Appendix G

Design Criteria

SUBJECT: Railyard Enterprise Project - Design Criteria and Intersection Controls for Phase 2 Alternatives

Comments on Railyard Enterprise Project Design Memo

FIGURE 1: ILLUSTRATIVE COMPLETE STREET CROSS-SECTIONS

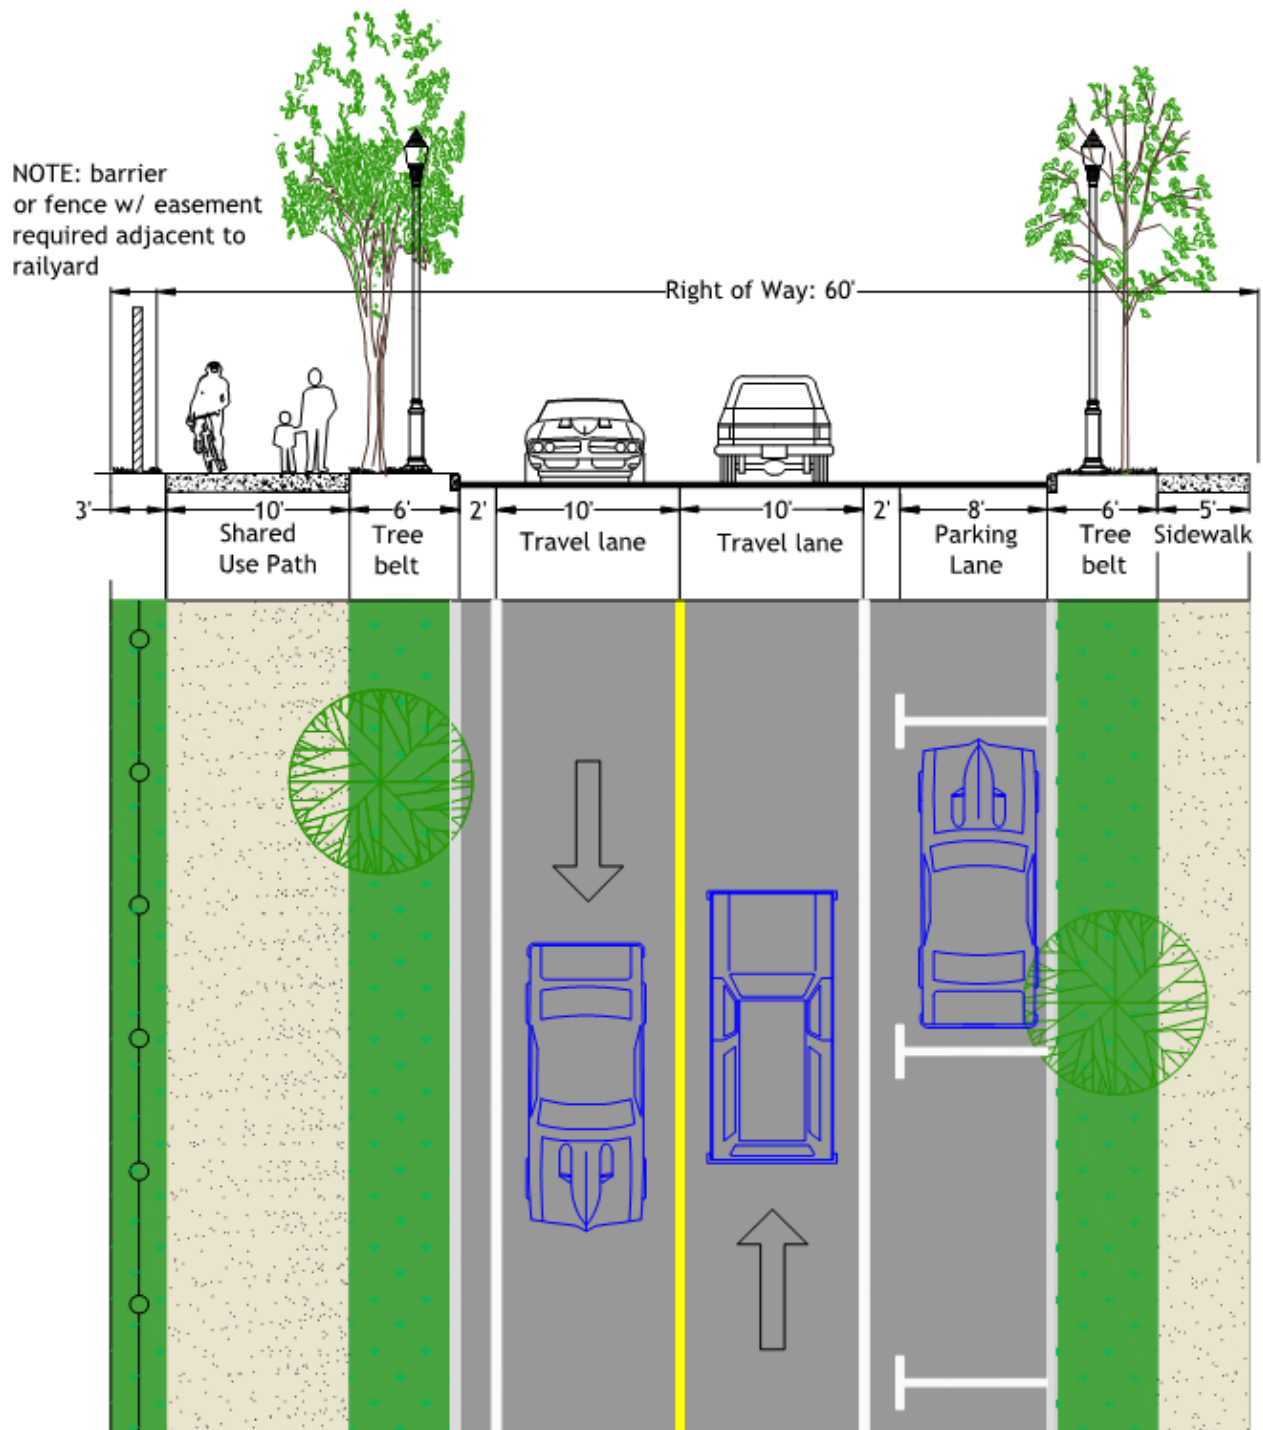
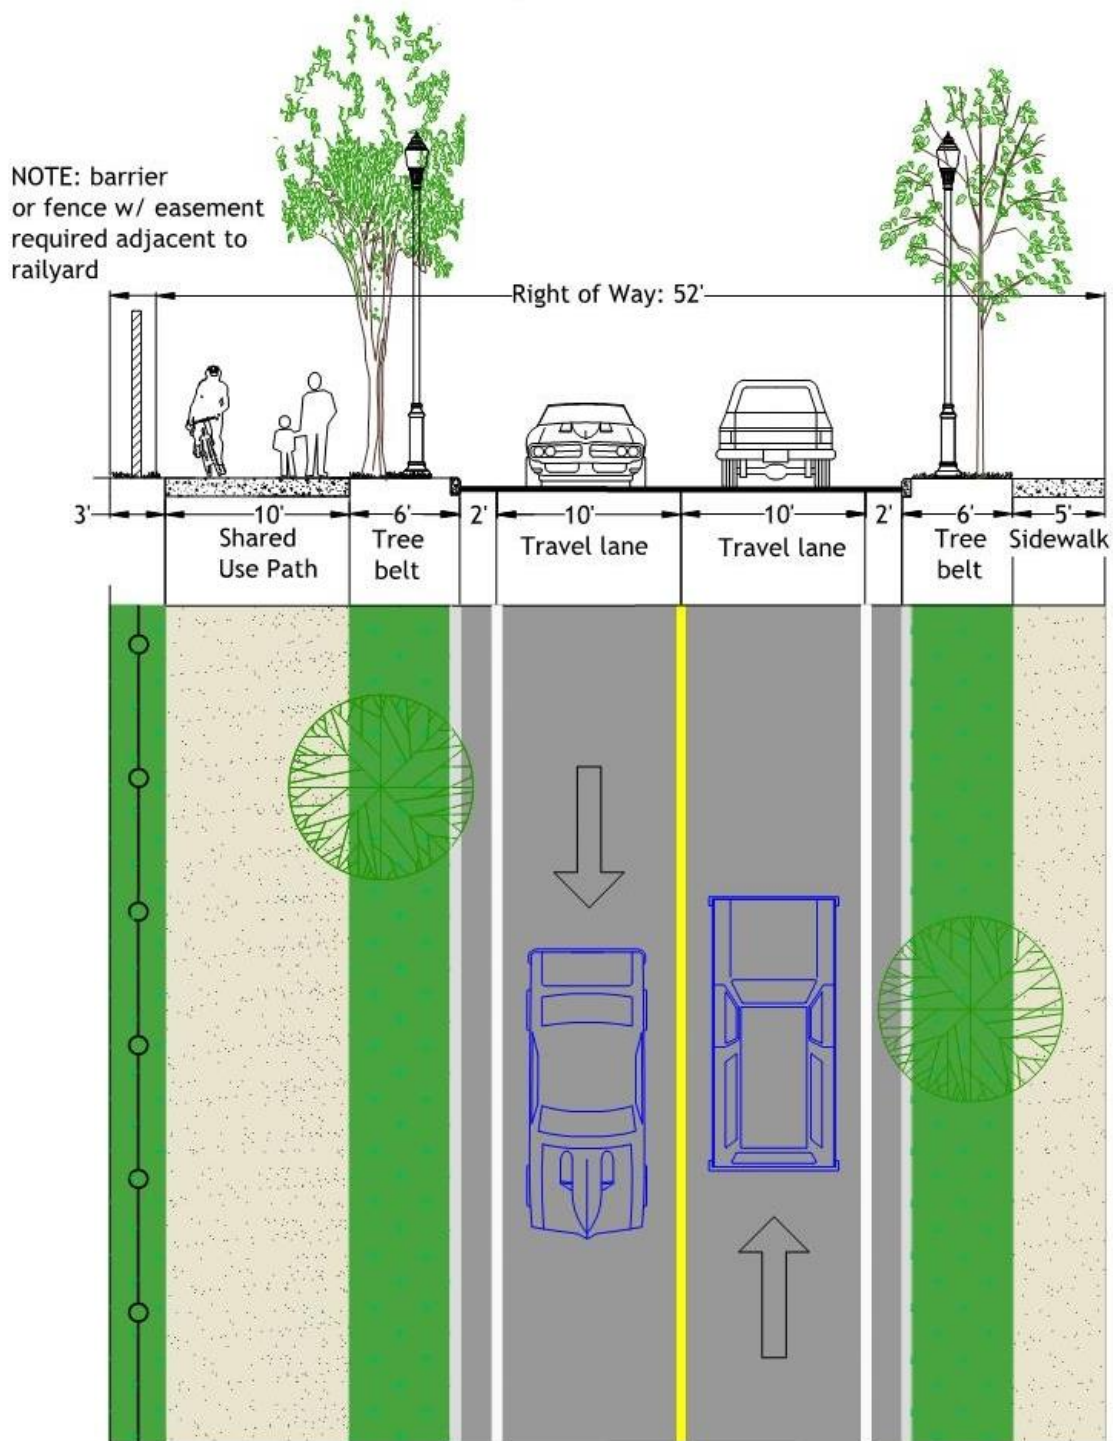
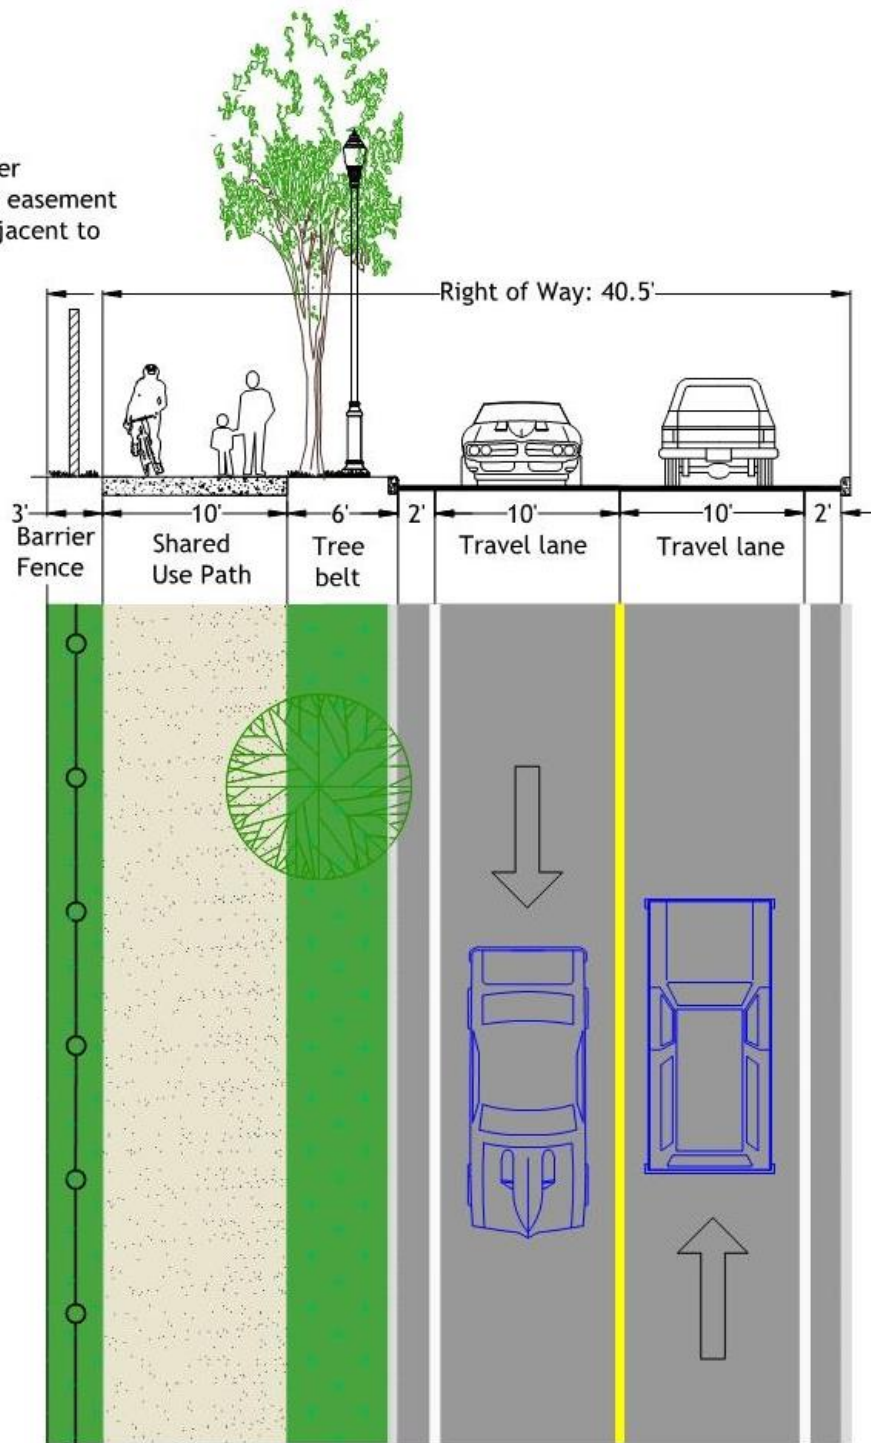
1. In the "Complete Streets" cross section, a 2' buffer between parking and a 10' travel lane is not needed, even on a major street with substantial large truck traffic.
2. Also in the "Complete Streets" cross section, a 2' shoulder is not needed if bikes are being accommodated in a separated path.
3. In the "Slow Streets" cross section, 22' of open asphalt (travel lanes plus shoulders/buffers) from curb to parked cars is excessive on a street that is intended to carry low volumes of traffic at slow speeds.

- For the "complete streets" cross-sections, reduce the shoulder for lanes that are up against the curb to 1' and eliminate the buffer for travel lanes that are up against on-street parking.
- For the "slow streets" cross-sections, eliminate the center yellow line and provide a total of 18' between parking and parking or between parking and the opposite curb.

Neither the Burlington Street Design Guidelines nor the NACTO Guidelines address the 2' shoulder/buffer. The striped buffer serves multiple purposes:

1. To define a narrow travel way for slowing traffic.
2. To provide an offset to the vertical curb.
3. To provide some latitude for larger vehicles such as CCTA buses, which are 10.5 feet mirror-to-mirror.
4. To provide space for stormwater drainage.
5. To provide an offset to the occasional car door opening (Complete Street #1).
6. To provide a temporary storage space for plowed snow.

- *Willard Street (US7 north of the Shelburne Street rotary) is comparable in road classification, traffic volume, and mix of vehicle types. It is 31 feet curb-to-curb (August 23).* We do not necessarily agree that the function of Willard Street is the same as the Complete Street being envisioned in the REP, and we do not yet have an estimate of traffic to compare to. However, at 32 feet curb-to-curb, Complete Street #1 is only one foot wider than Willard Street. Complete Streets #2 and #3 are considerably narrower at 24' curb-to-curb.
